**NRC RAI Letter No. PTN-RAI-LTR-037**

**SRP Section: 02.05.02 - Vibratory Ground Motion**

**NRC RAI Number: 02.05.02-13 (eRAI 5896)**

**Figure 1. Seismic Sources from the U.S. Geological Survey's 2008 National Seismic Hazard Mapping Project**  
(Petersen et al. 2008 FSAR Reference 300)

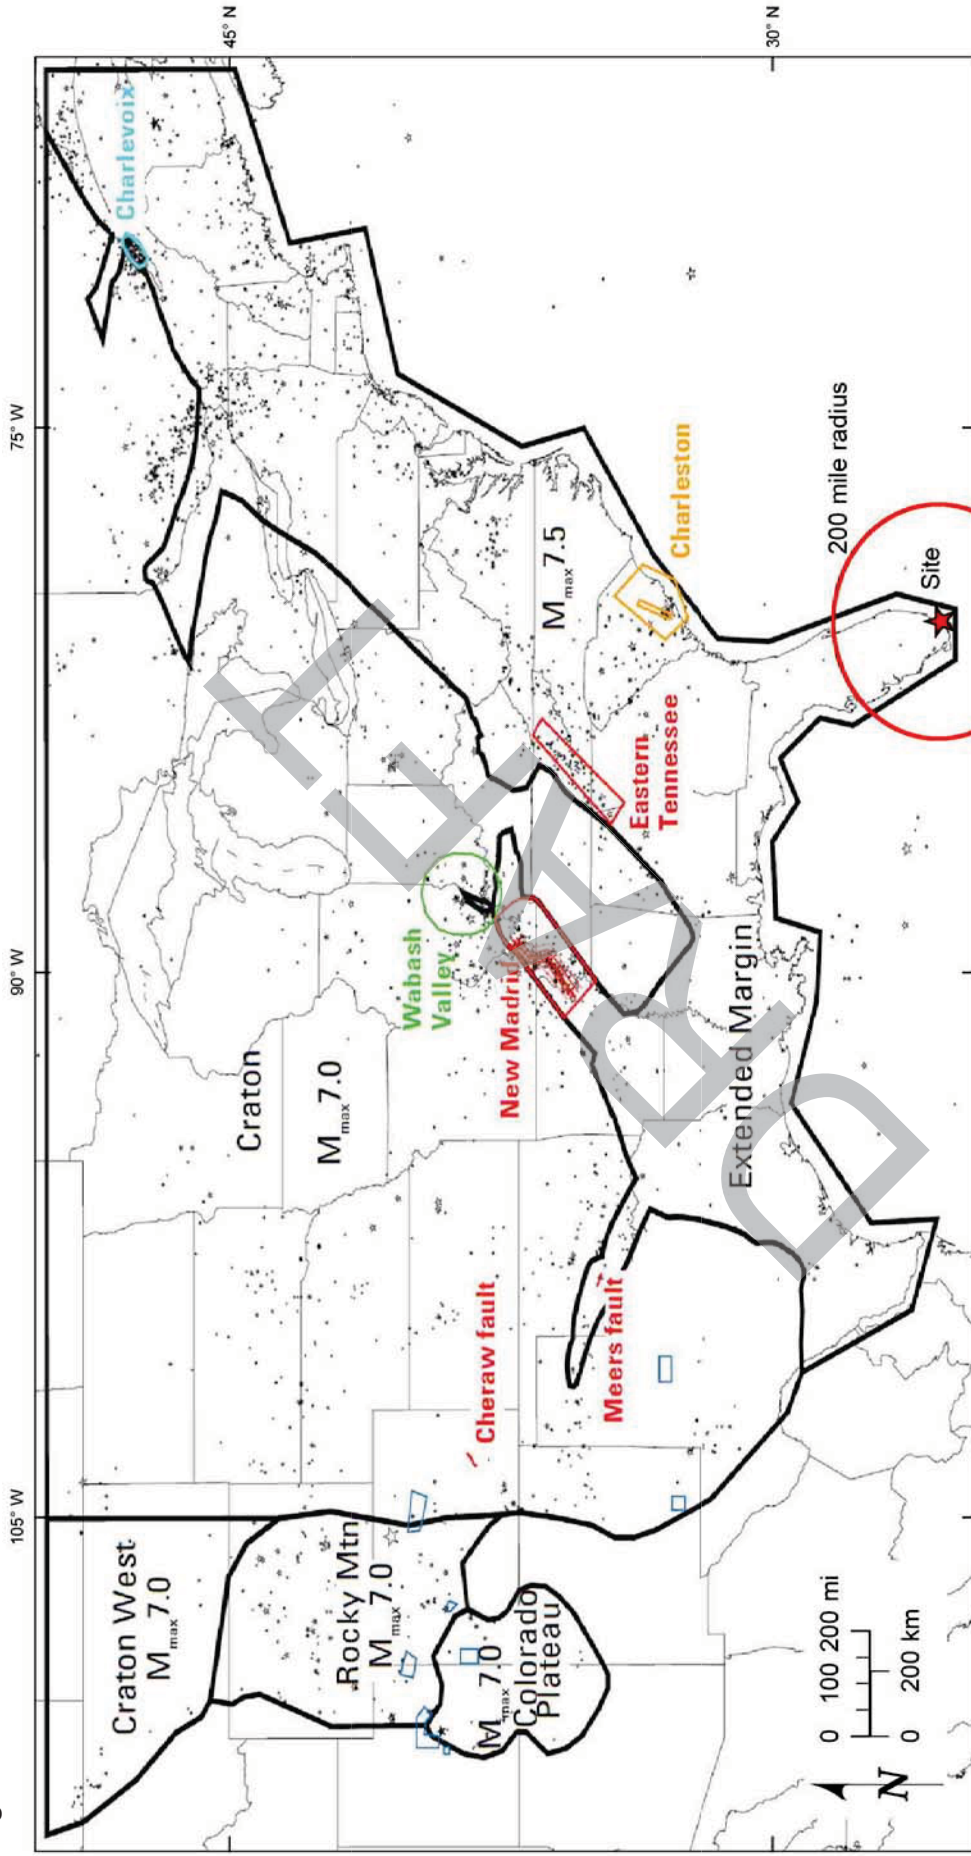
The FSAR does not list the USGS national seismic hazard map project as a potential source for EPRI seismic source model updates. The USGS regularly updates its own national seismic hazard maps using the most recent data and information. Within the last decade, the USGS published two comprehensive national seismic hazard reports in 2002 and 2008. RG 1.208 indicates that existing seismic source models should be evaluated in light of more recent data and evolving knowledge. Please discuss why the USGS national seismic hazard maps and model parameters are not discussed as potential studies to be considered in updating the existing EPRI seismic source geometries and/or model parameters.

The 2008 NSHMP earthquake sources are depicted in Figure 1. Significant changes from the 2002 NSHMP (FSAR Reference 251) model of seismic hazard in the CEUS include: (1) uncertainty in the maximum magnitude ( $M_{max}$ ) assigned to  $M_{max}$  zones (e.g., Extended Margin); (2) revised geometry of the Charleston seismic source zones; and (3) revised magnitudes, rates, and geometry for the New Madrid seismic source. As a result of these updates, the 2008 NSHMP characterizes  $M_{max}$  for the Extended Margin and Craton as weighted distributions ranging between  $M7.1 - 7.7$  and  $M6.6 - 7.2$ , respectively. The two areal zones defining the Charleston source are both assigned  $M_{max}$  distributions of  $M6.8 - 7.5$  with a recurrence interval of 550 years, unchanged from the 2002 NSHMP (FSAR Reference 251). The Charleston seismic source updates from the NSHMP (FSAR Reference 300) are discussed in Subsections 2.5.2.4.4.2.2 and 2.5.2.4.4.2.3.

The NSHMP model only covers a small portion of the site region (Figure 1) and does not include seismically active areas in the southern part of the site region and beyond, such as Cuba and the North America-Caribbean plate boundary that contribute to the seismic hazard in southern Florida. Therefore, a direct comparison between the NSHMP SSC model and the FSAR SSC model is not presented in the FSAR.
